STAFF RECOMMENDATION 926 Waldkirch Avenue January 18, 2017

Application: New construction—addition
District: Waverly-Belmont Neighborhood Conservation Zoning Overlay
Council District: 07
Map and Parcel Number: 10513034800
Applicant: Van Pond, Jr.
Project Lead: Melissa Baldock, melissa.baldock@nashville.gov

Description of Project: Application is to construct a rear addition.

Left elevation

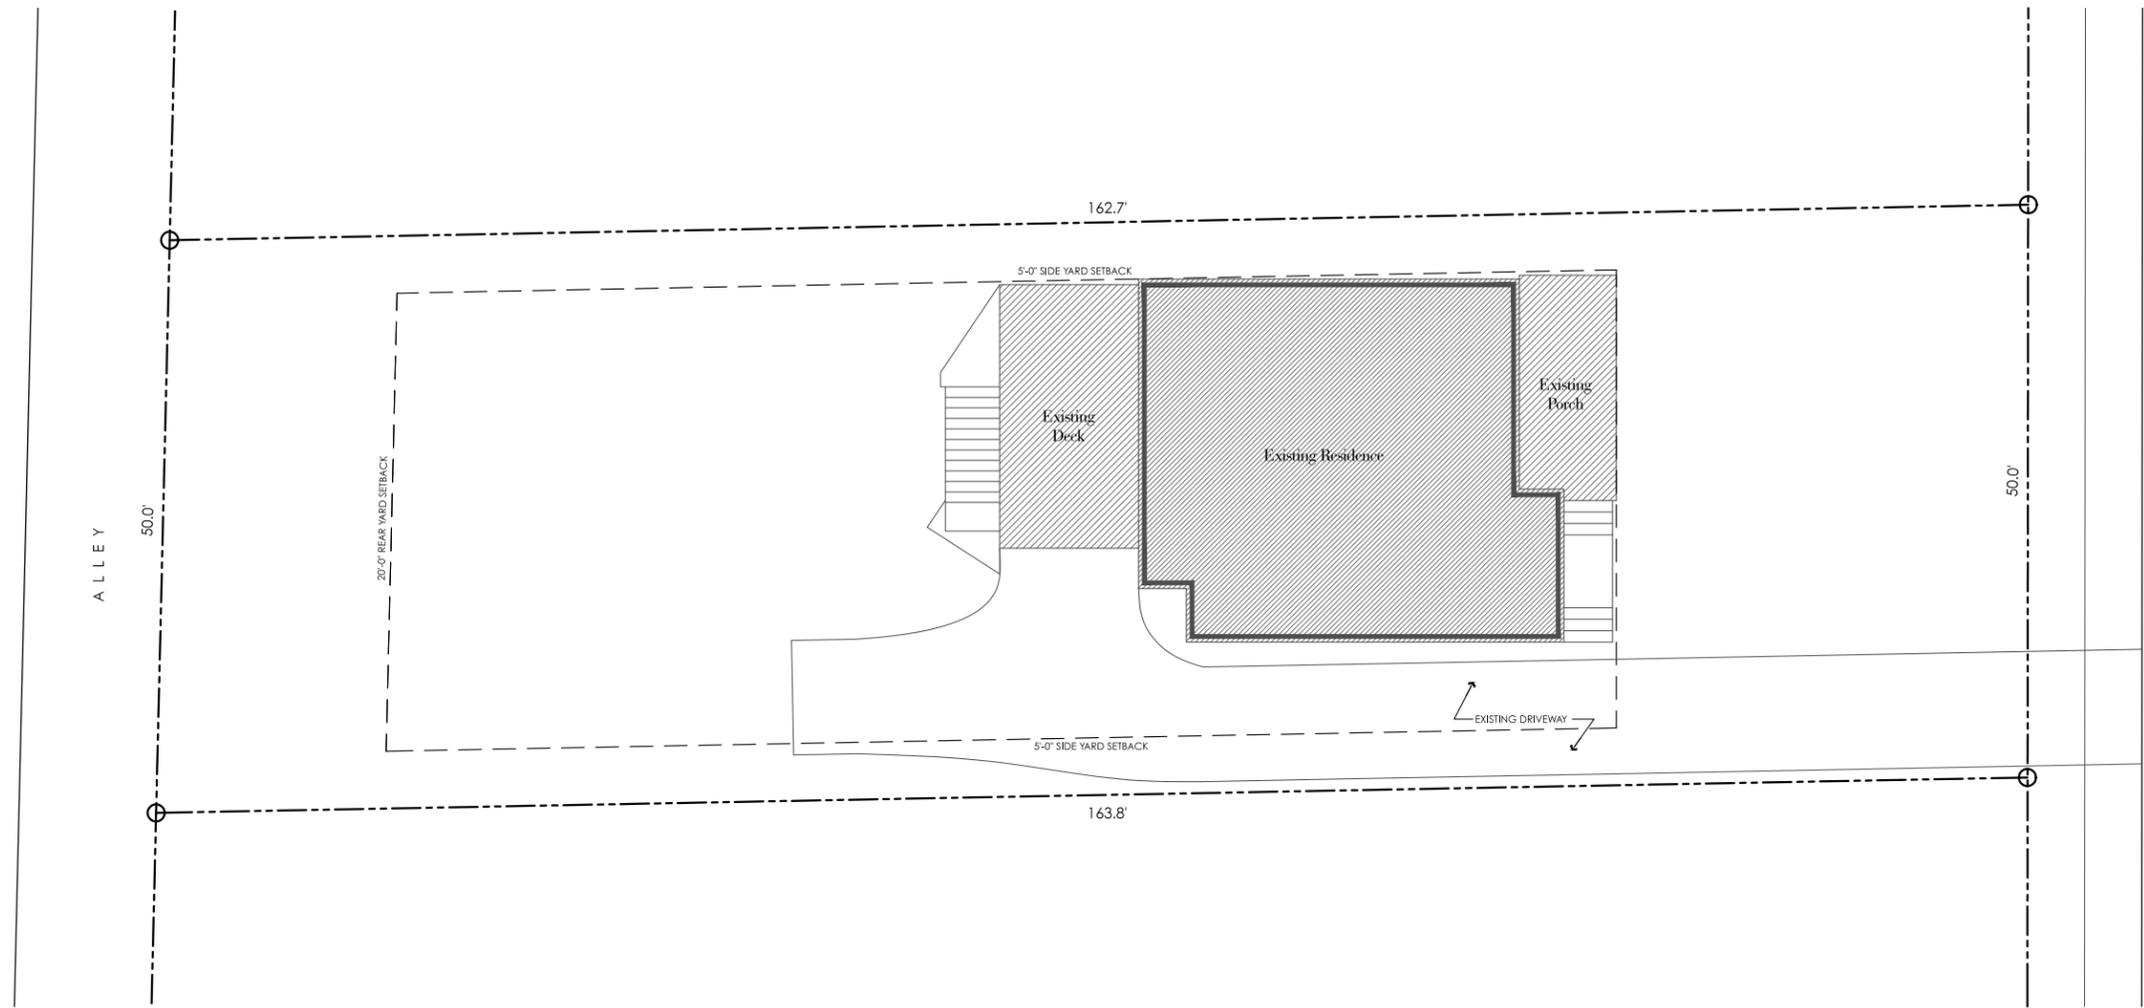
Height & Scale: The addition will add sixteen feet, six inches (16'6") of depth to the house, which is thirty-seven feet (37') deep. The addition is inset from the back corners of the house and is no wider than the historic house. The addition will add approximately four hundred and twenty-three square feet (423 sq. ft.) of footprint to the house, which currently has a footprint of one thousand and twenty-nine square feet (1,029 sq. ft.). Staff finds the proposed width, depth, and footprint to be appropriate and to meet the design guidelines.

The addition ties into the historic house at a point approximately nine inches (9") below the ridge of the historic house, which is appropriate. At a point approximately thirty-two feet, six inches (32'6") from the front of the house and thirteen feet (13') from the roof ridge, the addition increases in height to be sixteen inches (16") taller than the ridge of the historic house. Typically, the Commission requires that an addition not grow to be taller than the historic house until a point forty feet (40') back from the front. However, in this case, because the addition is only going up sixteen inches (16") and because the depth and footprint of the addition is modestly scaled, staff finds that the proposed increase in height is appropriate.

The foundation height of the addition will match the foundation height of the historic house. On the right elevation, the eave height will match that of the historic house. However, on the left elevation, the eave height will be approximately five feet (5') taller than that of the historic house. The taller eave height and the projecting two-story bay on this façade give it a two-story form. Staff finds the two-story form to be appropriate for this façade because it is set in over five feet (5') from the back wall of the house and will not be highly visible from the street. In addition, the modest depth and footprint of the addition ensure that the addition's overall scale is appropriate to the historic house.

The right elevation includes a 3/12 shed dormer that is set back over two feet (2') from the wall below. The left elevation includes a gabled second story bay with a 7/12 pitch. Staff finds that the proposed roof forms are compatible with the historic house and the historic neighborhood. Staff finds that the addition's roof forms meet Sections III.E and IV.C. of the design guidelines.

Proposed Site Plan

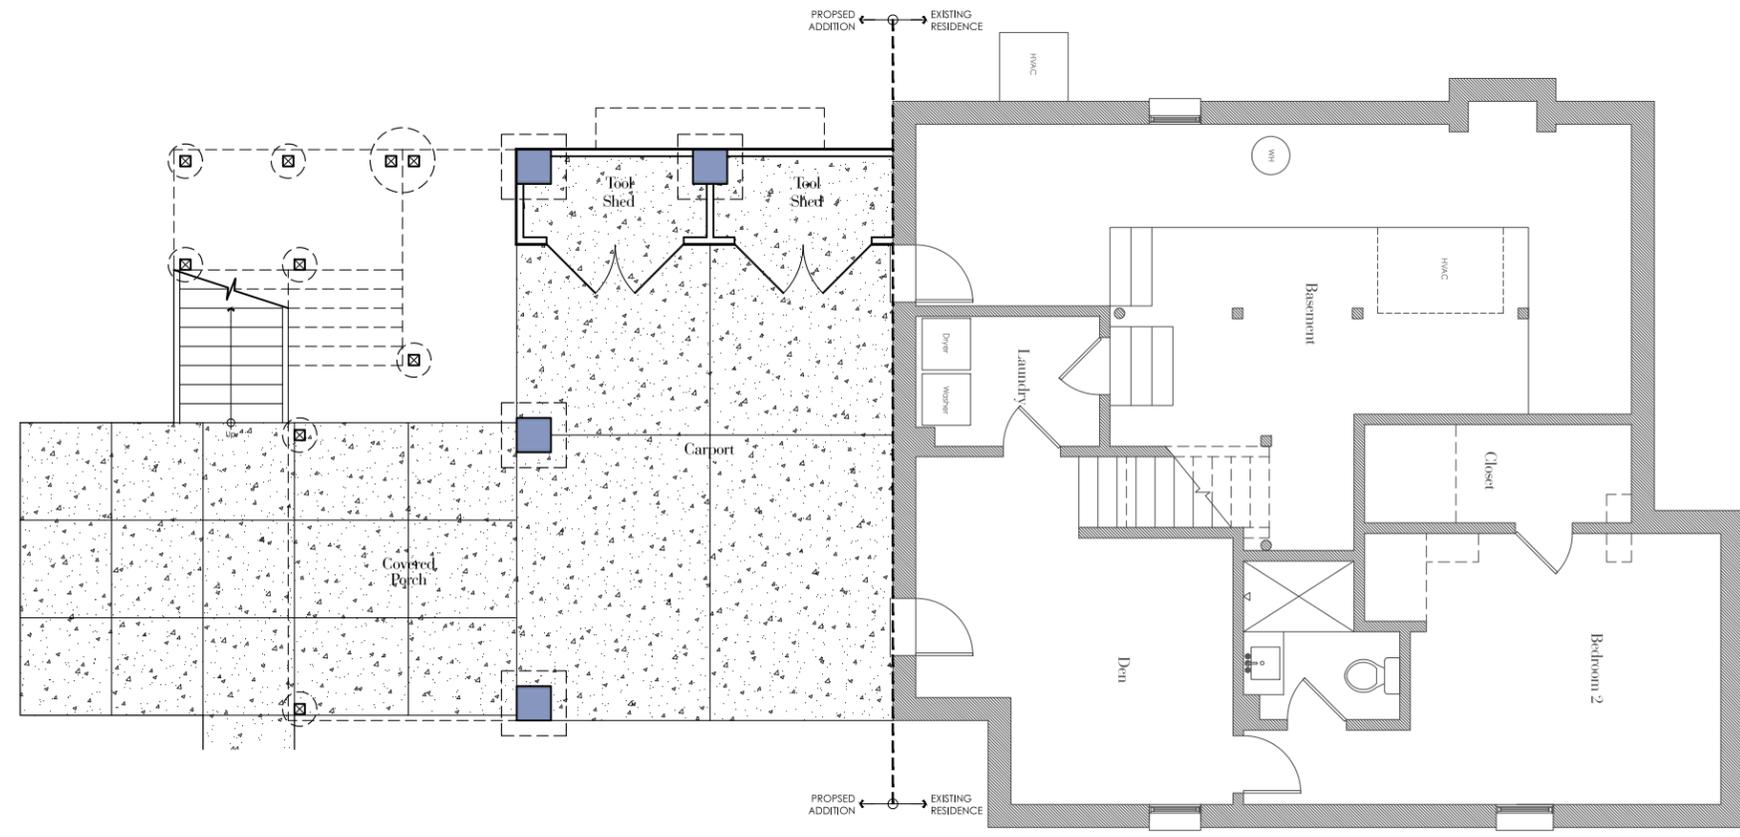
Setback & Rhythm of Spacing: The proposed addition meets all base zoning setbacks. It will be at least five feet (5') from the right side property line and eighteen feet (18') from the left side property line. It will be over sixty-five feet (65') from the rear property line. Staff finds that the project meets Section III.C. and IV.G. of the design guidelines.

Orientation: The new addition will not change the historic house's orientation towards Waldkirch Avenue. Vehicular access to the site will be via existing driveway, which will be extended further back to the lot. Staff finds that the project meets Sections III.F and IV.G. of the design guidelines.

Appurtenances & Utilities: The applicant intends to extend the existing driveway further to the rear of the property, which is appropriate and meets the design guidelines. The location of the HVAC and other utilities was also not noted. Staff asks that the HVAC be located on the rear façade, or on a side façade beyond the midpoint of the house.

2 Proposed Roof Plan

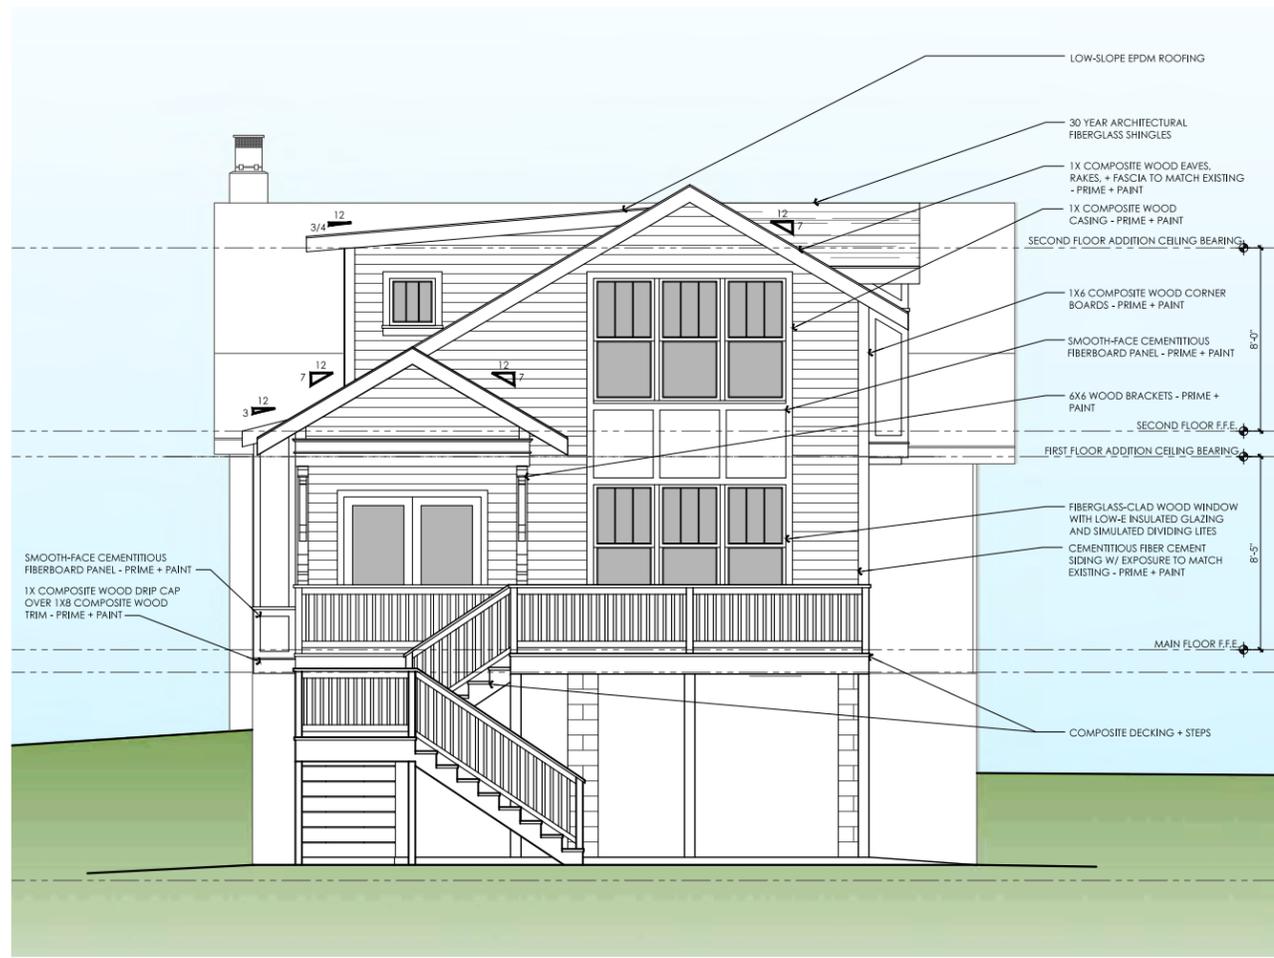
Roof form: The addition's primary roof form will be a gable with a 7/12 pitch. The portion of the addition that is sixteen inches (16") taller than the historic house is not clipped, as is typically required when an addition is taller. However, staff finds that because the addition is less than one and a half feet (1.5') taller than the historic house, and the taller portion is set back thirteen feet (13') from the roof ridge, the additional

height will not greatly impact the historic house when seen from the front.
